FINAL ENVIRONMENTAL IMPACT REPORT

Northern San Joaquin 230 kV Transmission Project

SCH # 2024010207

This chapter contains reproduced comments from letters received during the public review period for the Draft EIR, which concluded on February 7, 2025, including transcribed comments received during the January 15, 2025 public hearings. The comment letters below are reproduced exactly as they were submitted. Spelling, grammatical, and other errors in the original letters have not been corrected.

Figure 3.11-1 Regional Hydrological Setting for the Project Area

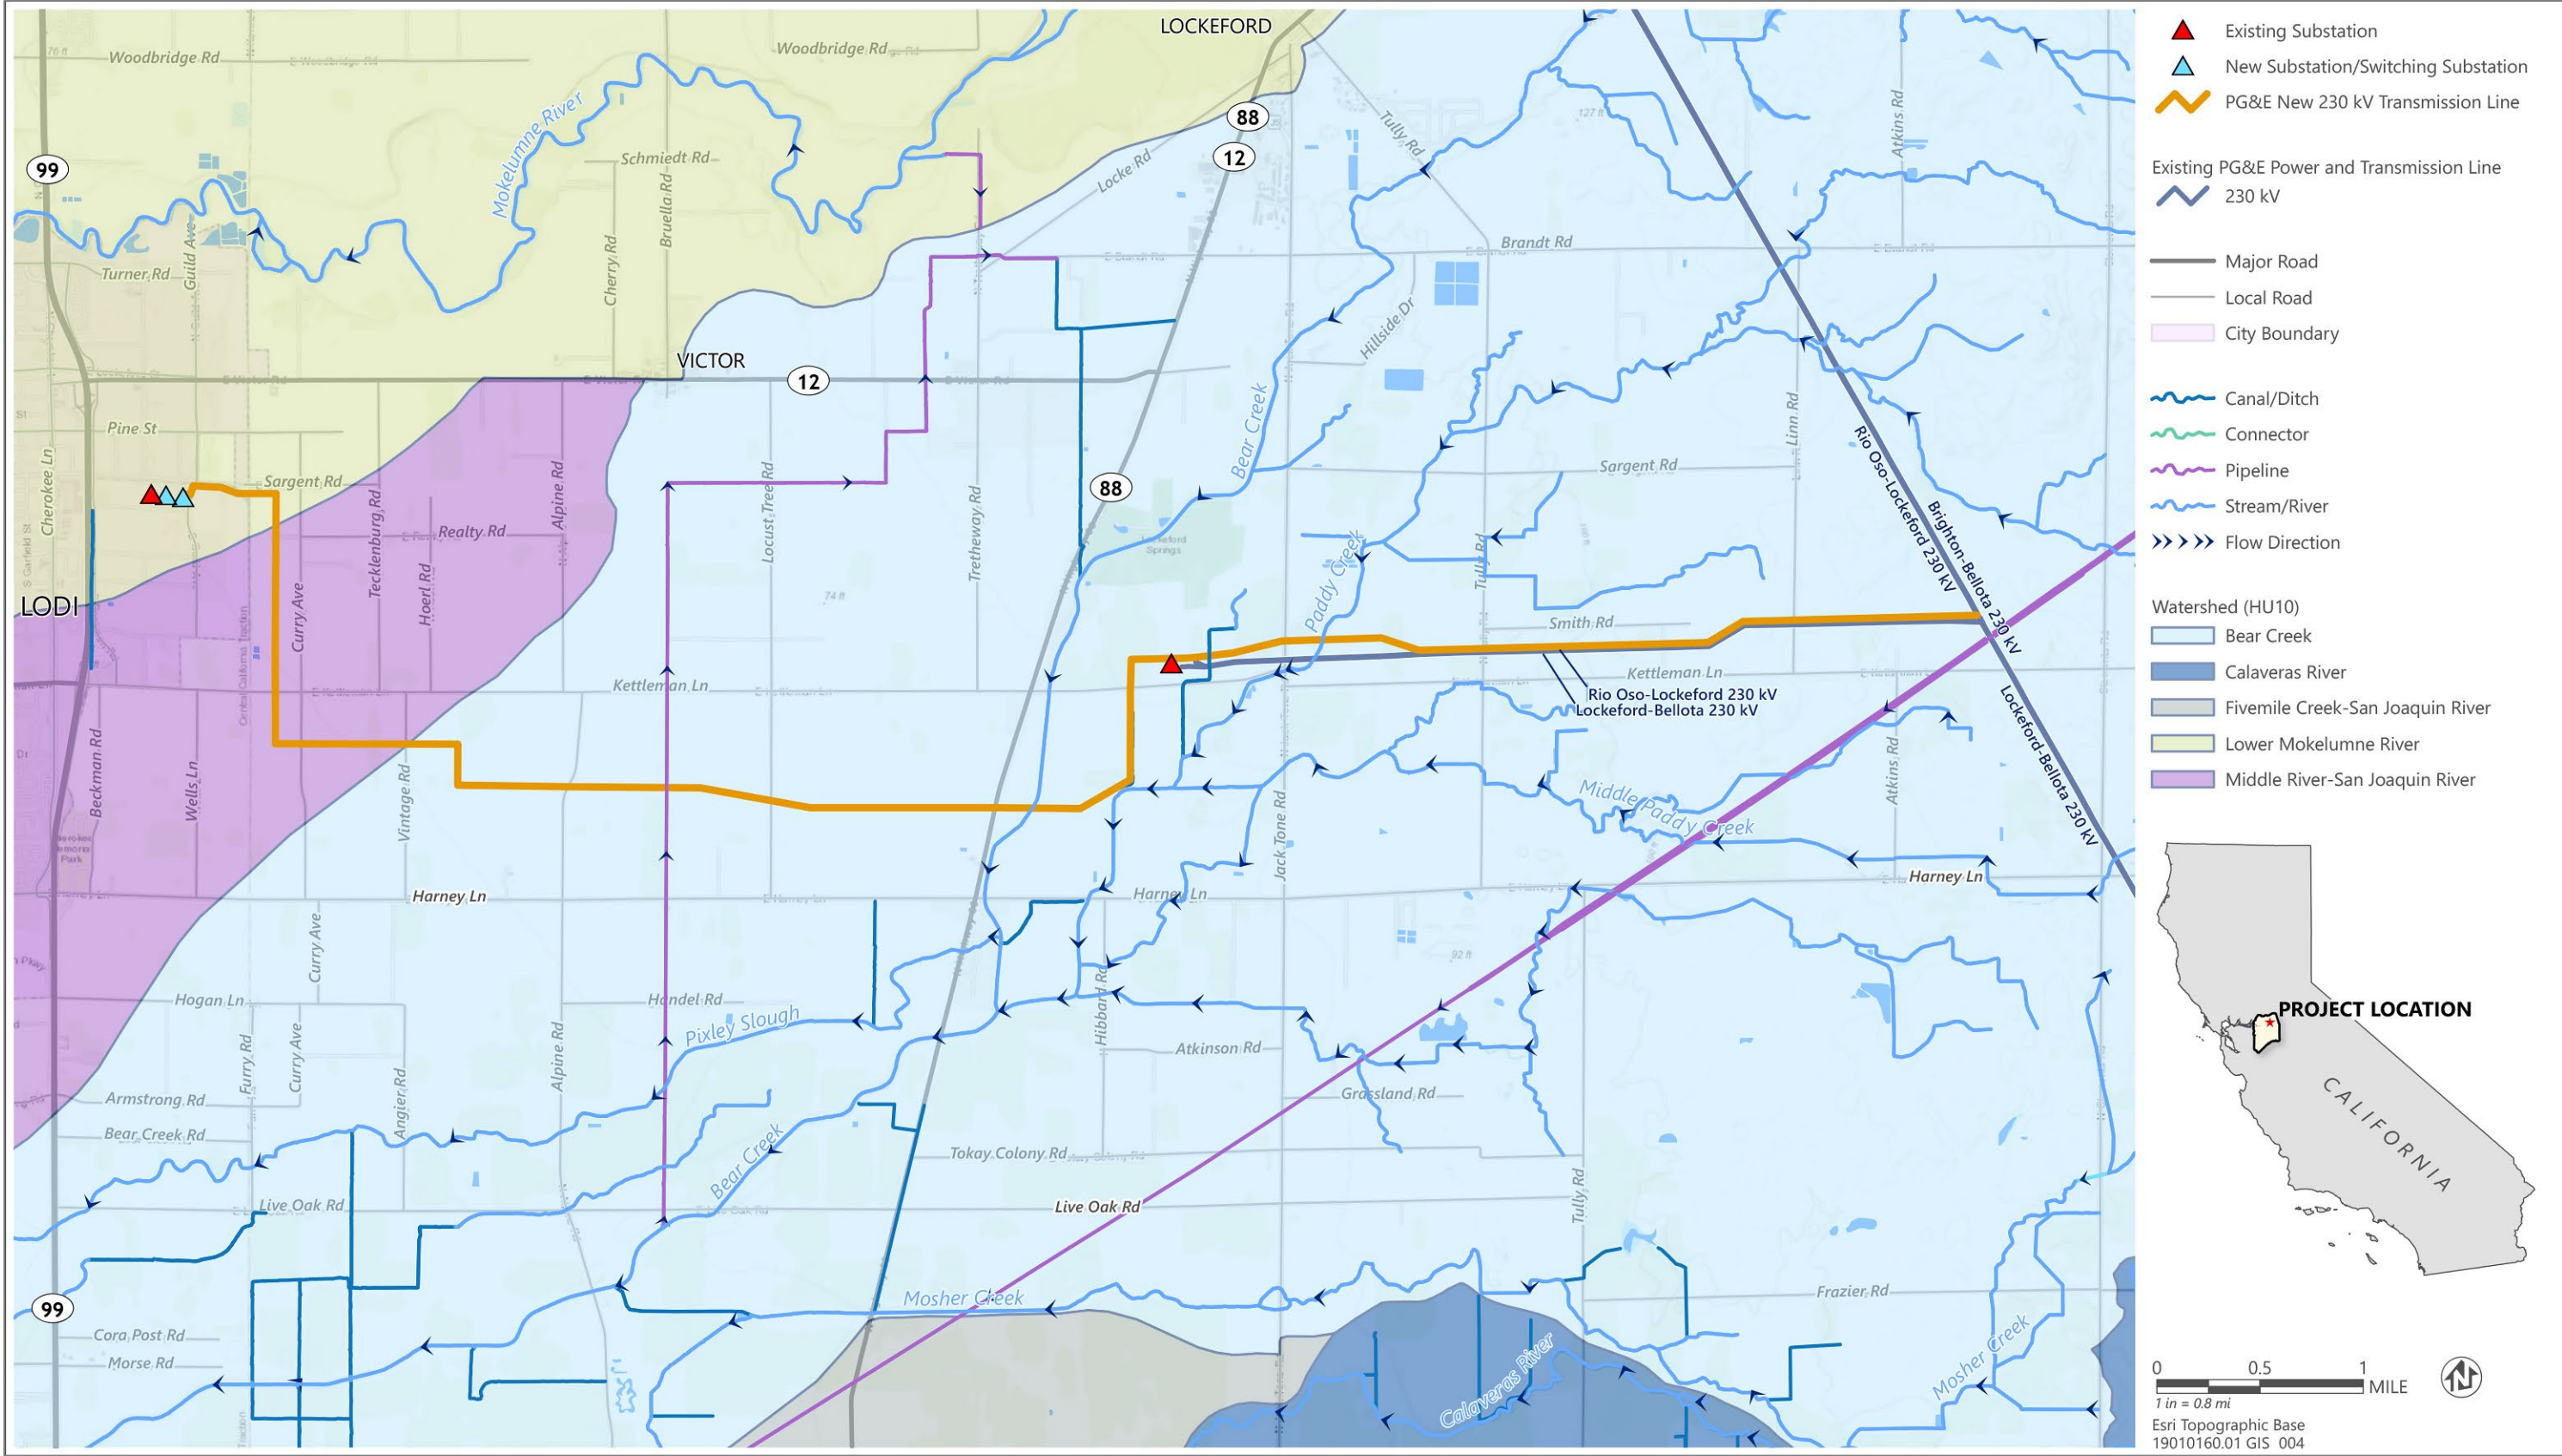
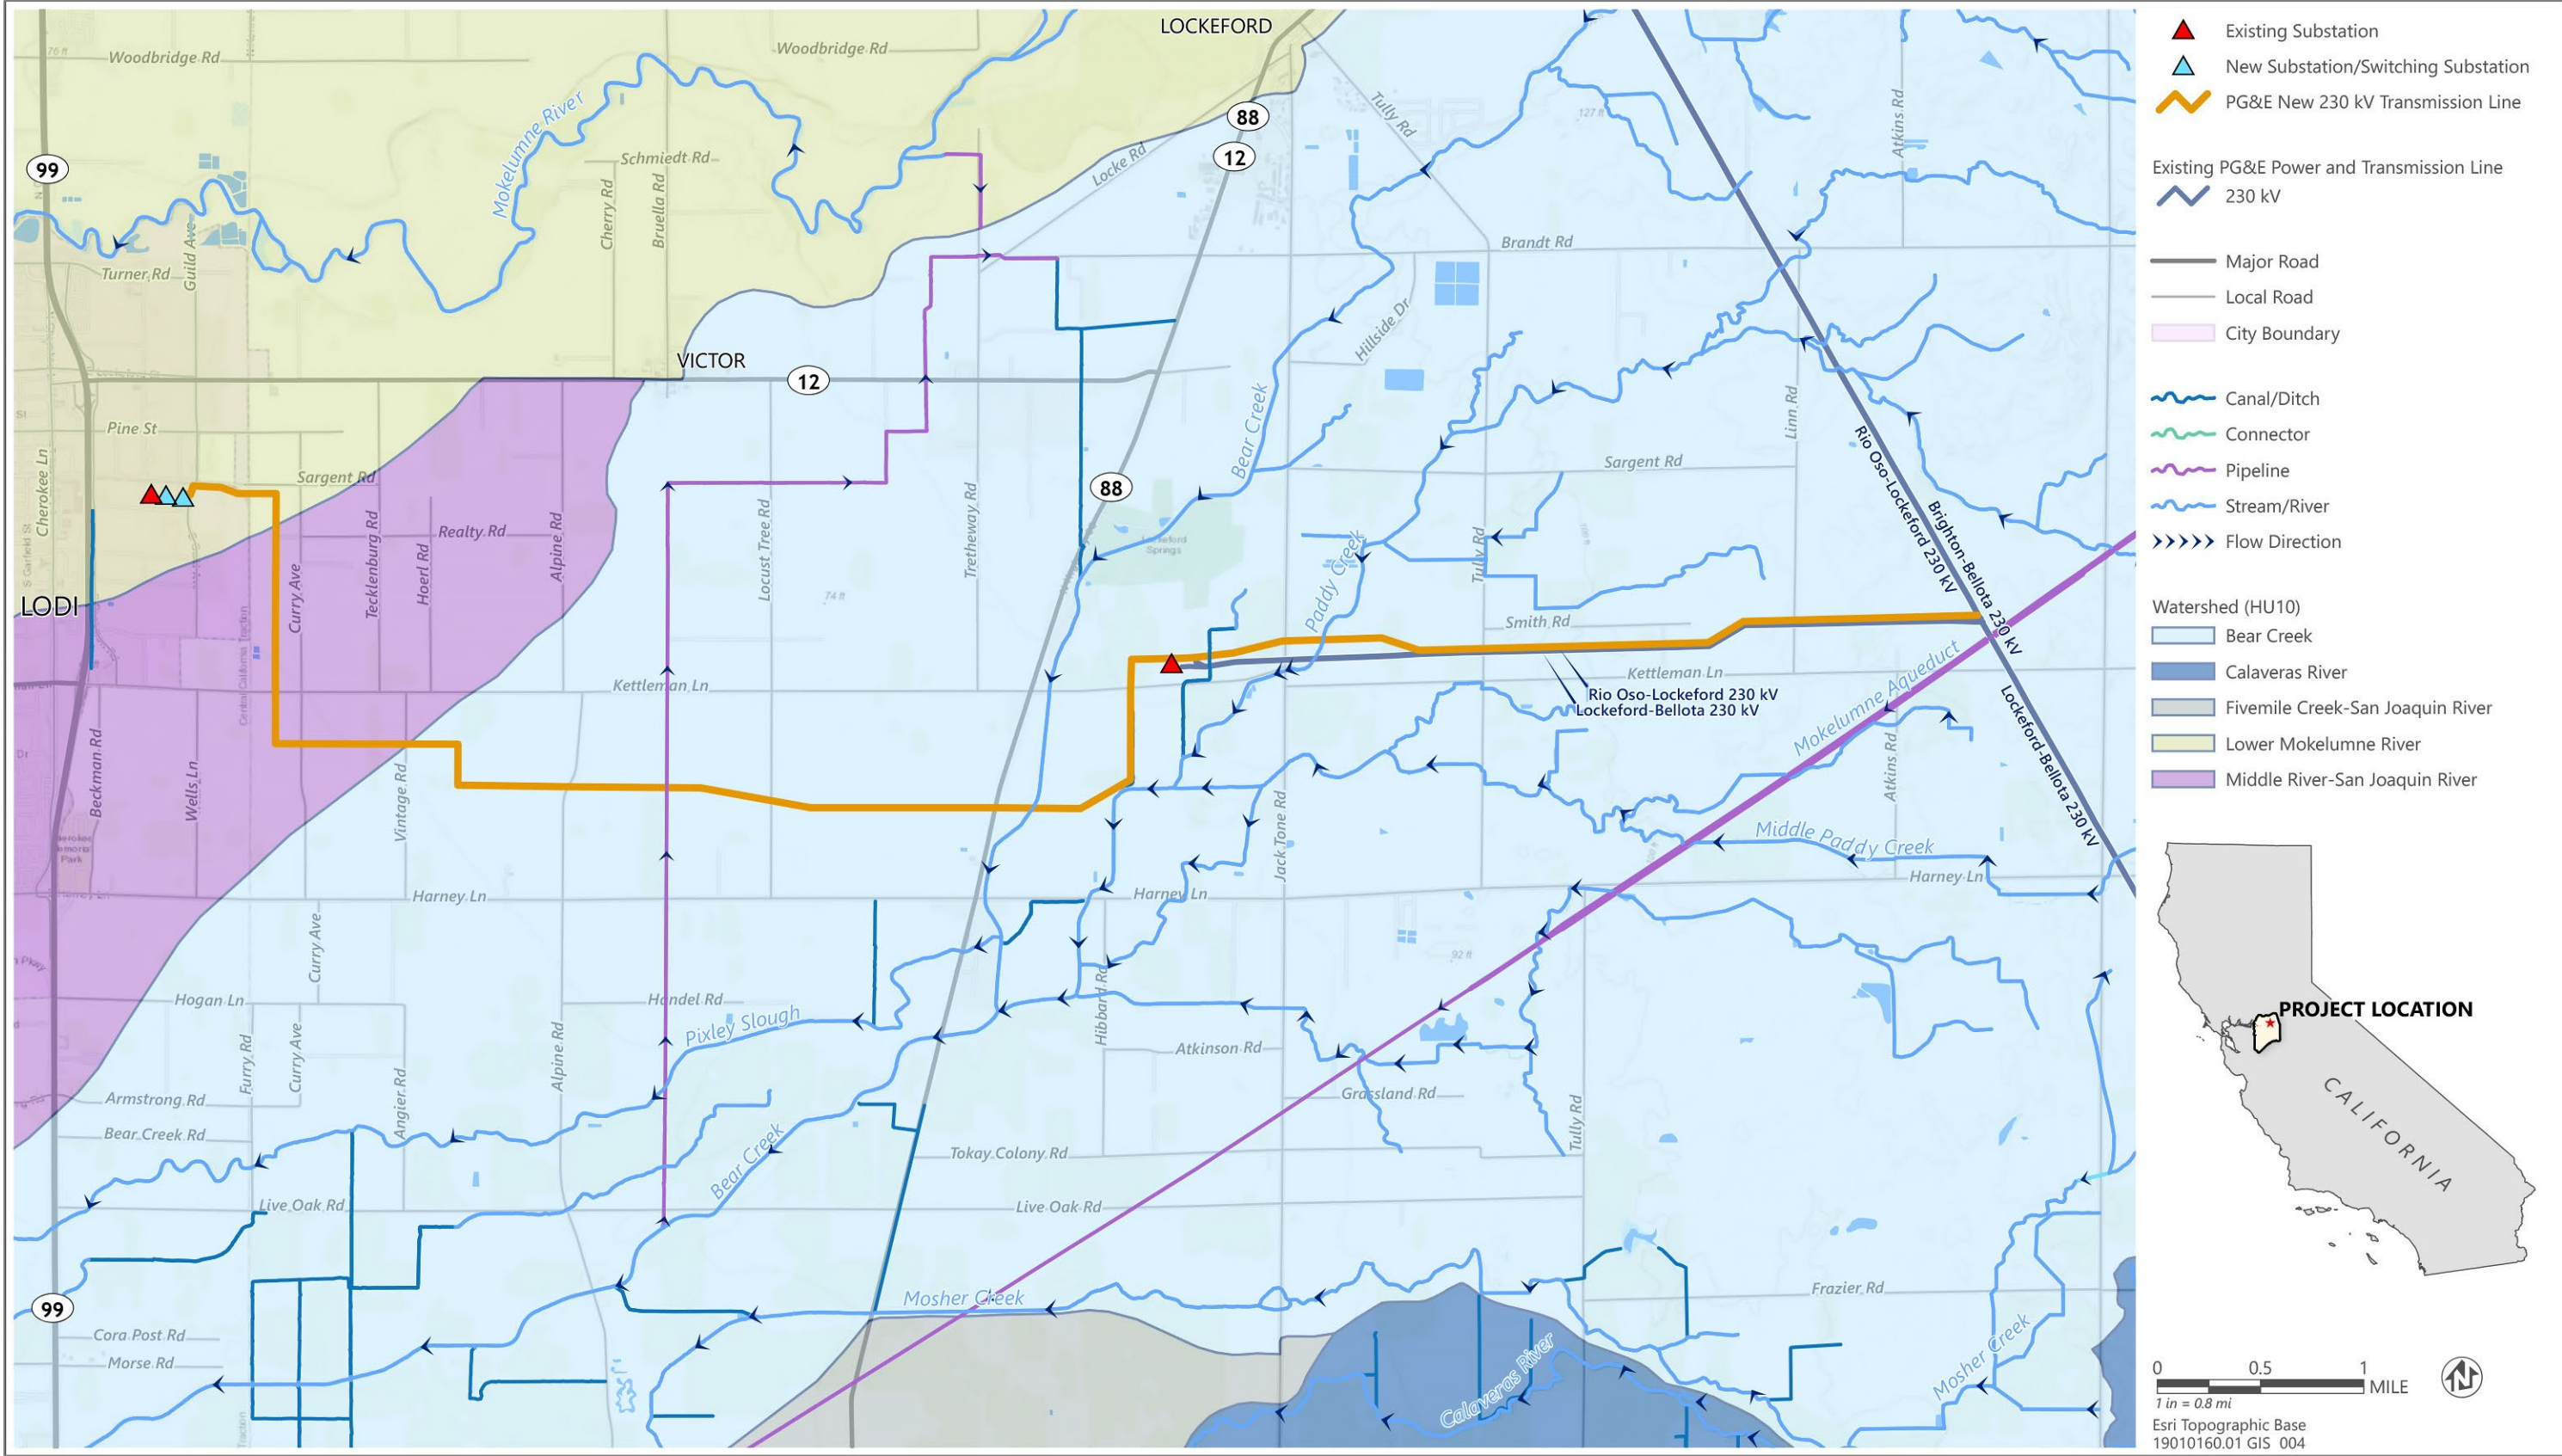
On page 3.11-3 of the Draft EIR, Section 3.11, Hydrology and Water Quality, Figure 3.11-1 depicts the alignment of EBMUD's Mokelumne Aqueducts (Aqueduct) in purple and should be labeled as such for reference.

Figure 3.11-1 the Draft EIR is revised as follows to label the Mokelumne Aqueduct in response to Comment A3-1.

Figure 3.11-1 has been revised to label the Mokelumne Aqueduct, as requested in the comment. Figure 3.11-1 depicts the project alignment within the Bear Creek, Middle River–San Joaquin River, and lower Mokelumne River watersheds and provides context for analysis of potential for effects to surface water quality. Although the figure depicts pipelines, including EBMUD's Mokelumne Aqueduct, only key surface waters referenced in the analysis are labeled in the Draft EIR. This figure is not intended to provide the context necessary for the project applicant to determine permitting requirements. It is assumed that PG&E will identify the aqueduct on all pertinent construction documents. Labeling the aqueduct does not affect the analysis or conclusion of the Draft EIR relative to potential for the project to affect the hydrology or water quality of the area.
